H. B. ROBINSON STEAM ELECTRIC PLANT, UNIT NO. 2
DOCKET NO. 50-261/LICENSE NO. DPR-23

**RESPONSE TO REQUEST FOR ADDITIONAL INFORMATION ON
TECHNICAL SPECIFICATIONS CHANGE REGARDING INOPERABLE
ANALOG ROD POSITION INDICATION FOR CONTROL ROD H-10 (TAC NO. MB7265)**

Figure 1. Simplified Diagram of ARPI Channel.

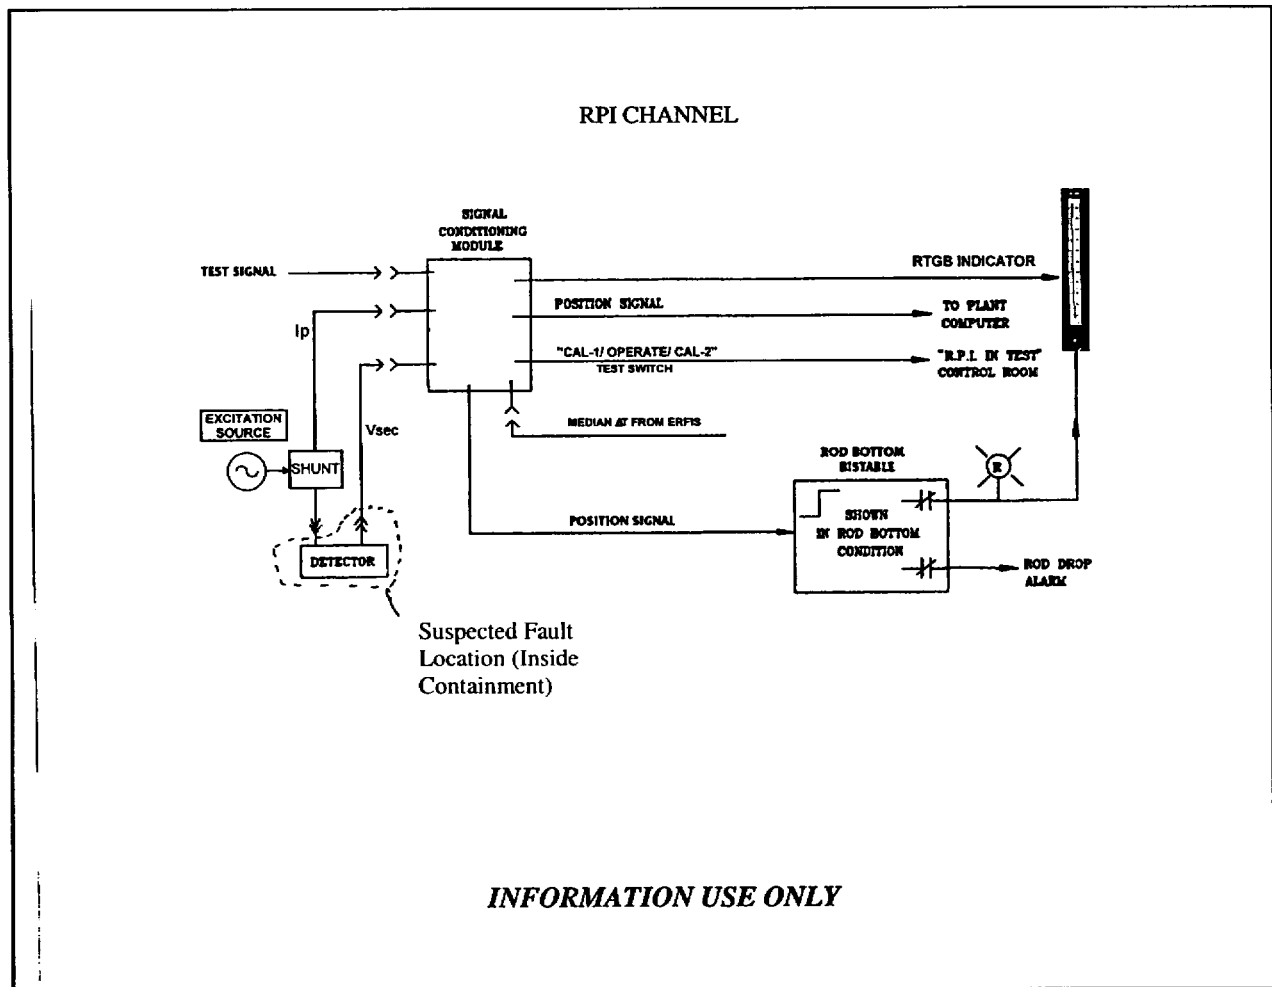
5. The licensee has concluded that the fault in the ARPI for Control Rod H-10 has occurred near the reactor vessel. The ARPI system provides input to alarms and additional instrumentation systems. The staff requests the licensee provide a one-line diagram of the ARPI system for Control Rod H-10. This diagram should identify the suspected fault location, the affected alarms, relays, or interlocks that receive input from the system, and a description of how the fault will affect their operation. For any affected alarms, relays, or interlocks, the staff requests the licensee describe compensatory measures that will be used to offset the loss of these features.

A simplified diagram of the RPI channel is provided as Figure 1. The fault is believed to be in the cable connector at the top of the ARPI detector or in the ARPI detector itself. The affected alarms/functions are the rod bottom indicator for Control Rod H-10, the rod misalignment alarm for Control Rod H-10, and the rod drop alarm for Control Rod H-10. The January 16, 2003, license amendment request states the following:

“A drop or unexpected substantial movement of Control Rod H-10 while the reactor is operating would be immediately detected by the excore neutron detector system. Other indications of the negative reactivity insertion associated with this condition would include power and temperature fluctuations that would be observable by the Reactor Operator. These diverse indications provide a means of determining that a rod drop or misalignment has occurred. Use of these diverse indications to detect a rod drop or unexpected substantial movement are available when an ARPI is not operable, and these indications are not affected by use of the proposed alternate method for verification of Control Rod H-10 position.”

The HBRSEP, Unit No. 2, TS require that the position of a control rod with an inoperable ARPI be verified by the use of the movable incore detector system once per 8 hours, in accordance with TS 3.1.7, Required Action A.1. The proposed license amendment request provides an alternate means for accomplishing this required verification. The alarms/functions associated with the ARPI that are not available are not affected by the use of alternate means of verification. The proposed alternate monitoring method provides an additional method for detection of a possible deviation of Control Rod H-10 from the required position. No additional compensatory measures are required for the alarms/functions that are not available.
